COTTAGE GROVE CITY COUNCIL

July 17, 2024

- H Sale of Surplus Property
Staff Recommendation: Authorize Public Works to advertise and sell surplus property on Cranky Ape.
 - I Utility & Engineering Building Change Orders
Staff Recommendation: Approve the June 2024 Change Order Requests for the Utility & Engineering Building Project.

F1 MEZZANINE LEVEL - AREA B
1/8" = 1'-0"

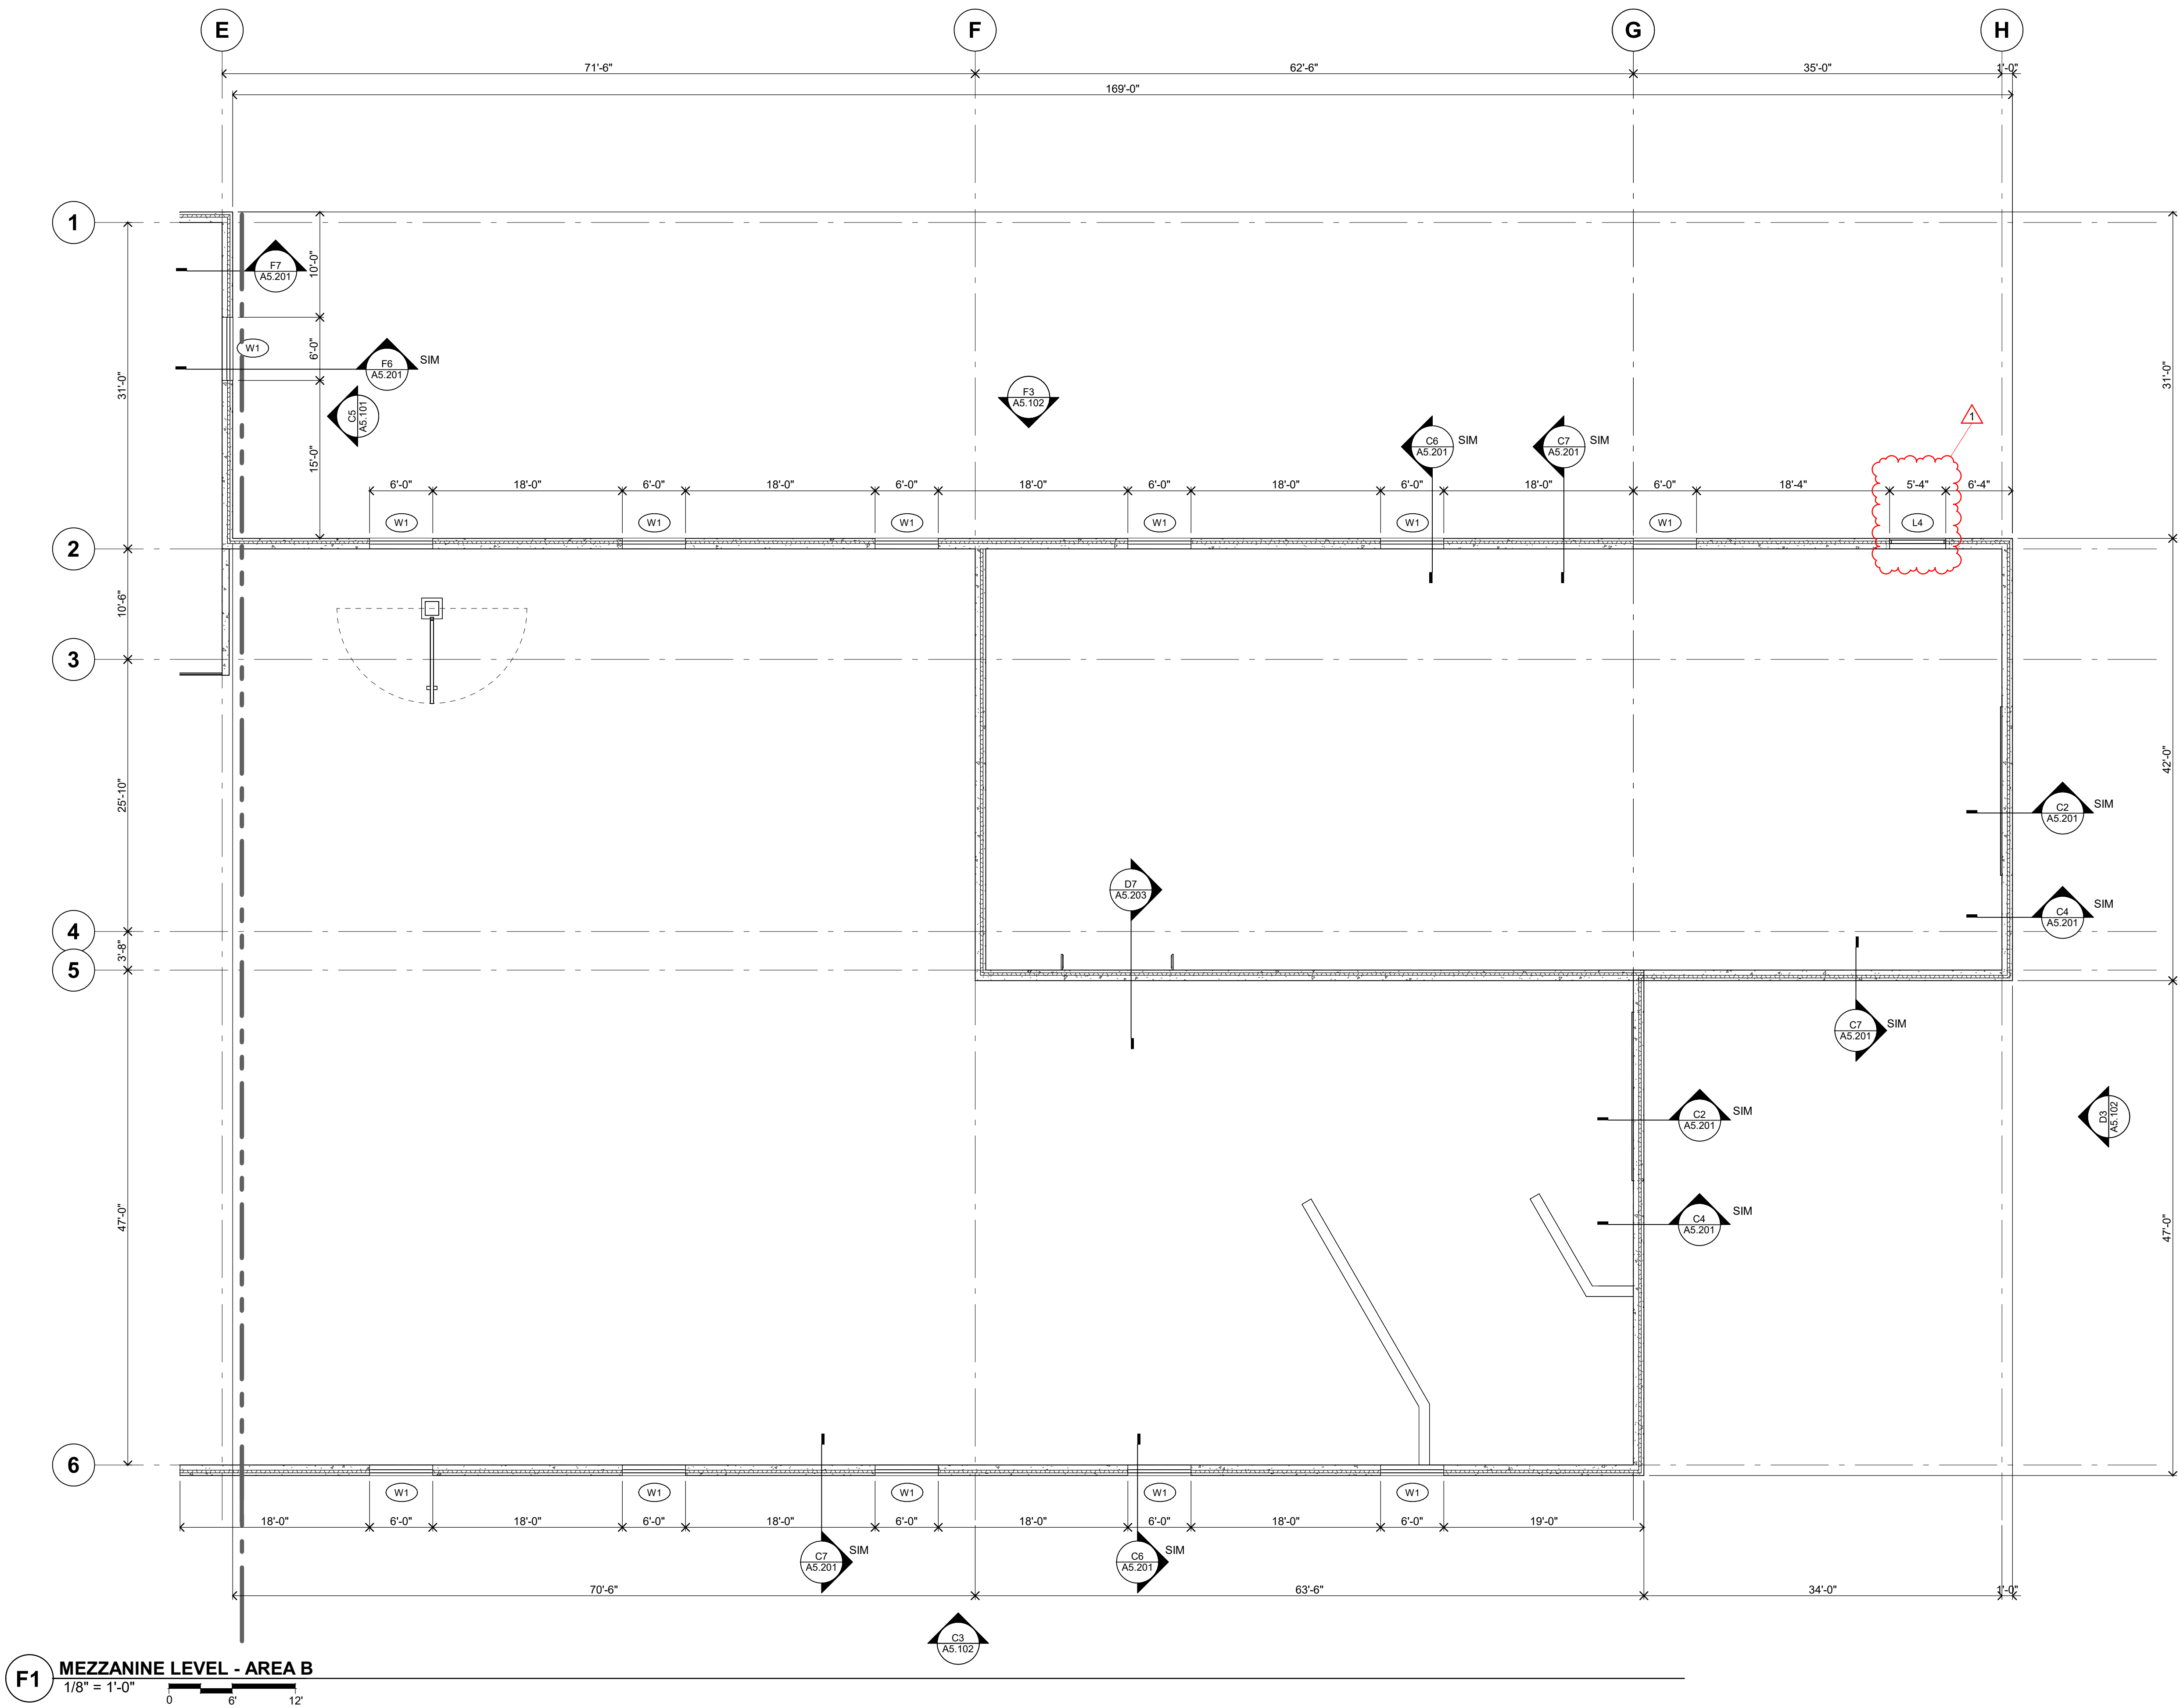
Item	Description
1	Door Revision & Window/Louver Revision
1.1	See Door / Opening Schedules on sheets A2.01a, A2.01b, A2.02a for modified door materials.
1.2	Refer to plan on sheet A2.01a and elevation on sheet A4.101 for revised dimension of door A126B.
1.3	Refer to plans on sheets A2.01b, A2.02b and elevation on sheet A5.102 for revised louver sill height. Provide credit for removed window.

E1 SOUTH ELEVATION - AREA A

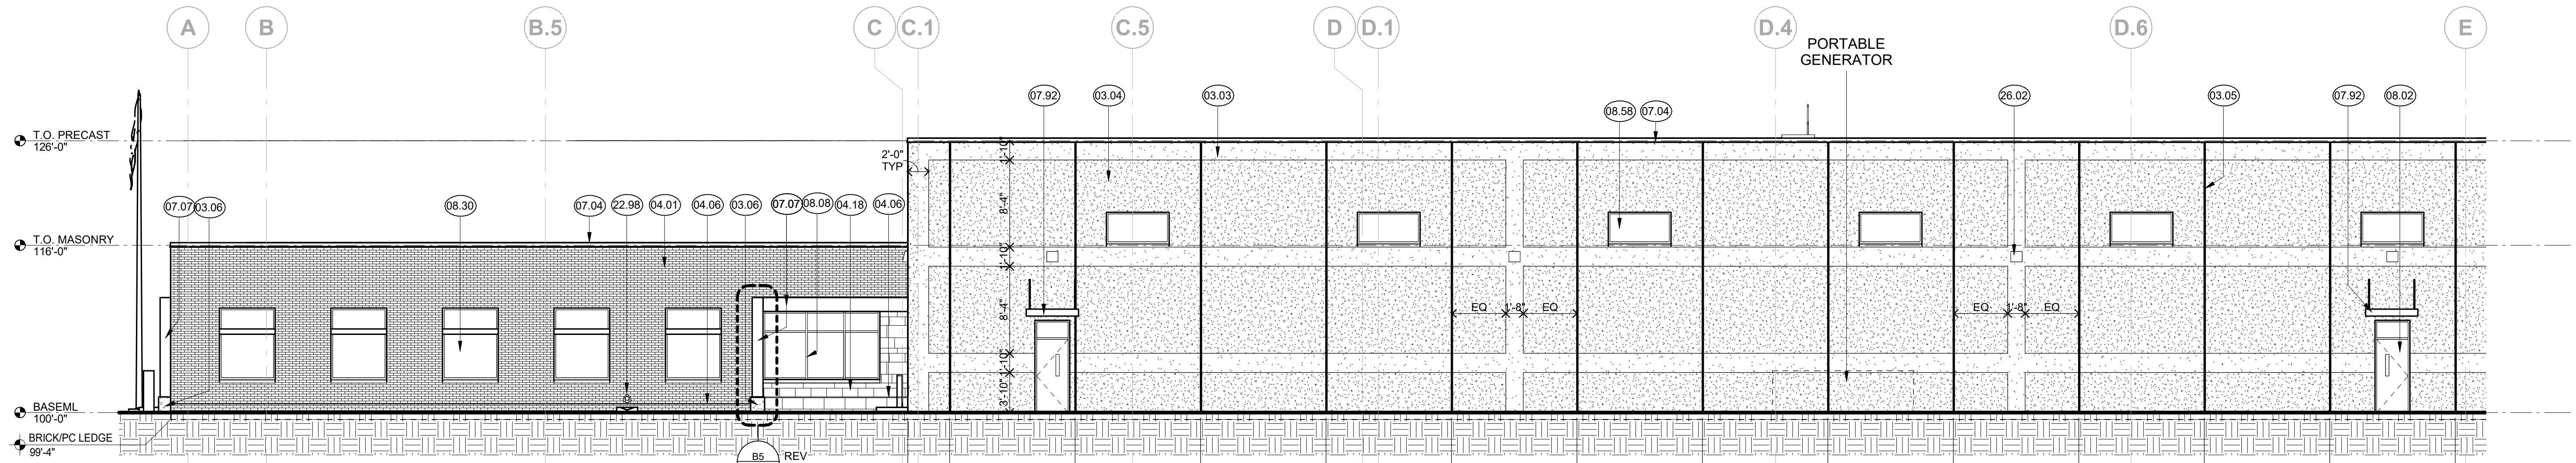
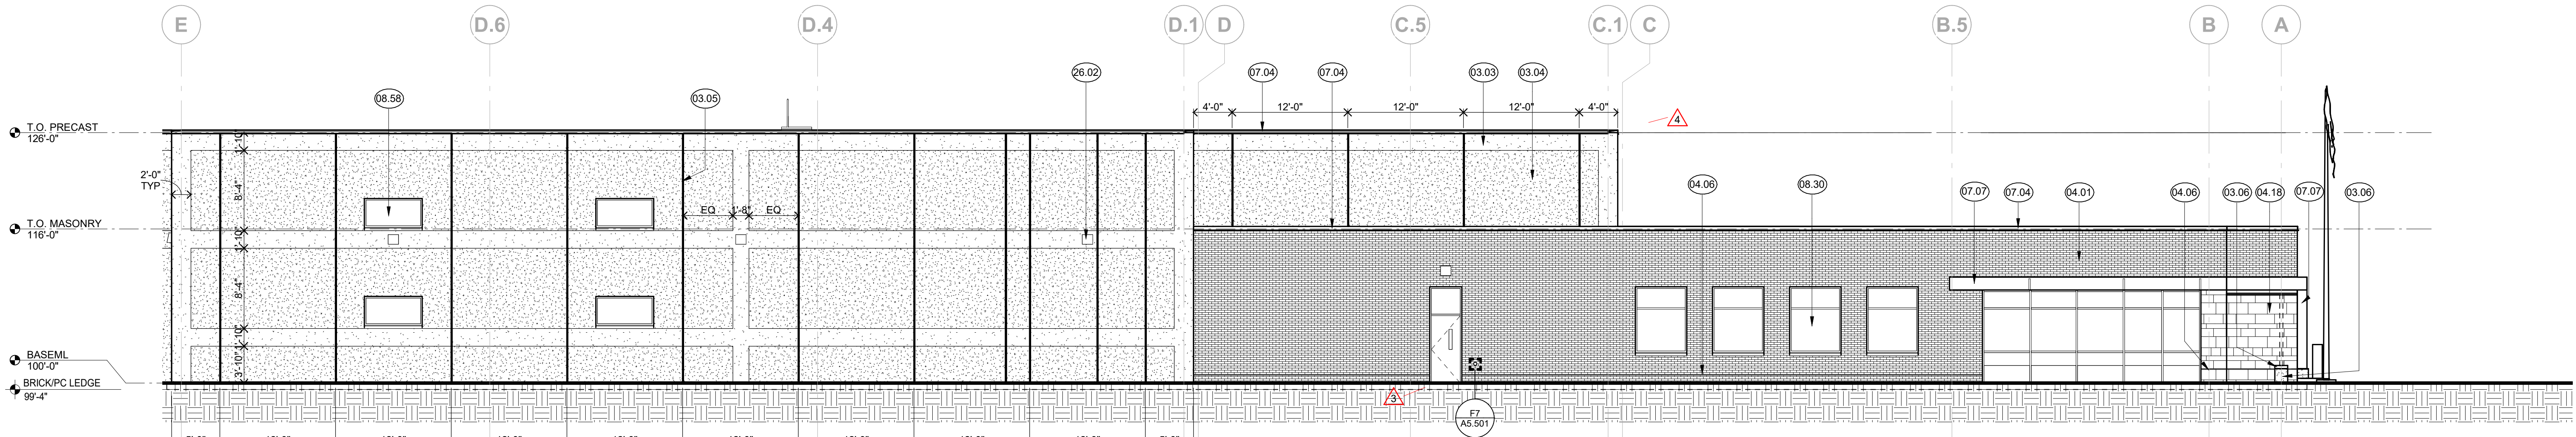
Item	Description
1	Precast Structural Concrete Finish Revision
1.1	Refer to materials key on sheets A5.101 and A5.102 for modified finishes of precast structural concrete.

E1 SOUTH ELEVATION - AREA A

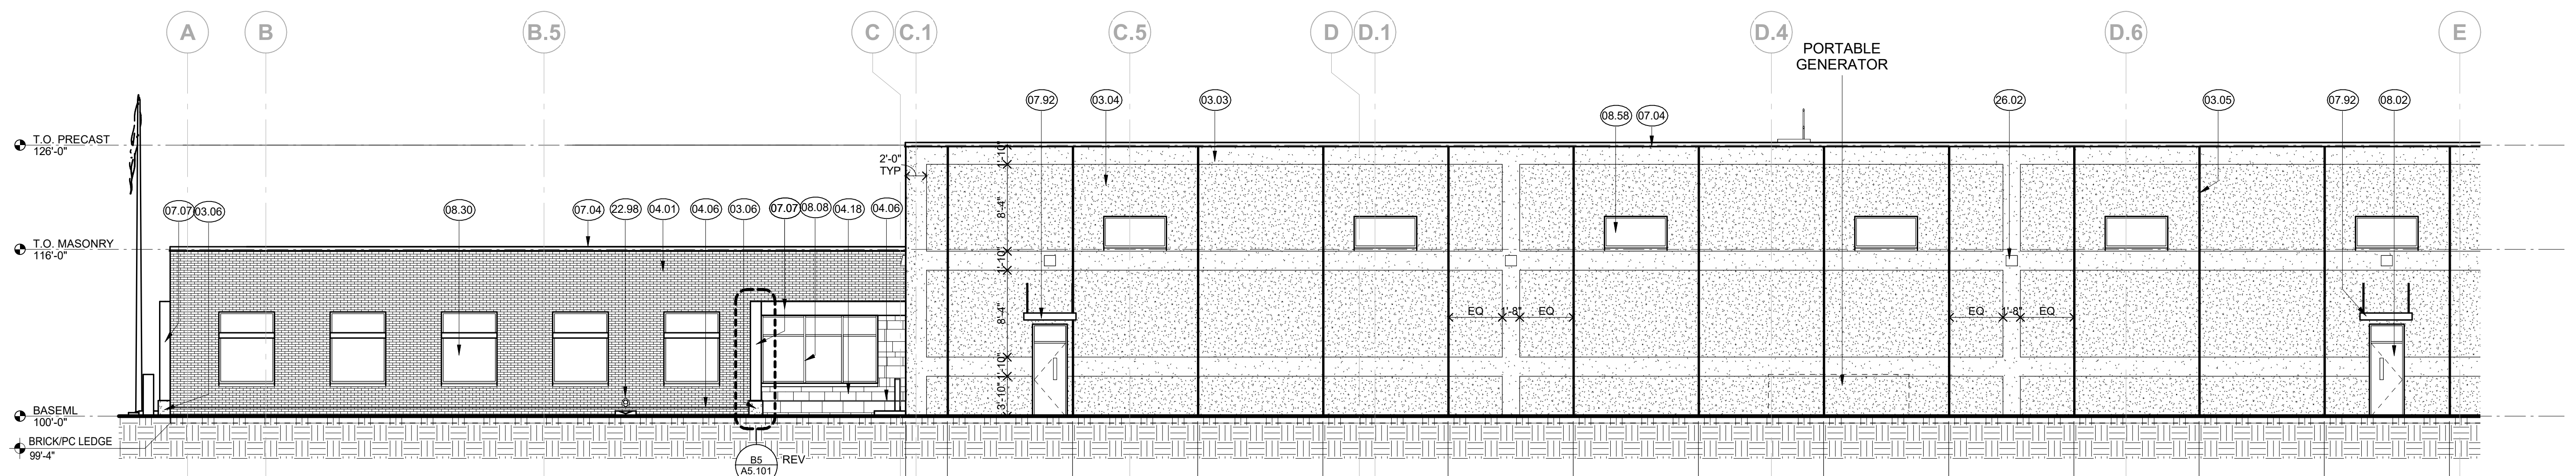
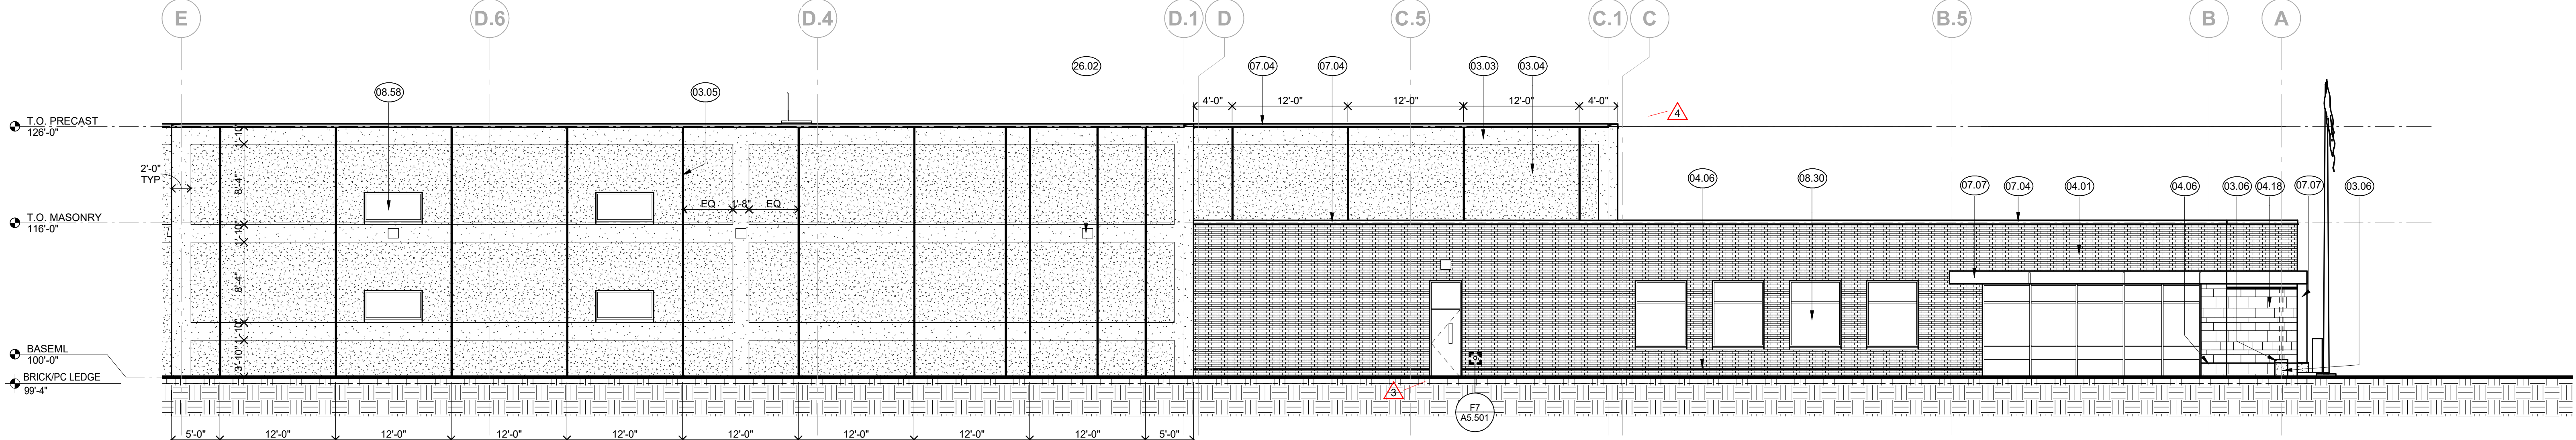
Item	Description
7	Window Removal
7.1	See revised sheet A2.02a MEZZANINE LEVEL FLOOR PLAN AREA 'A' and A5.101 EXTERIOR ELEVATIONS for removed window. Provide credit for the removed window.
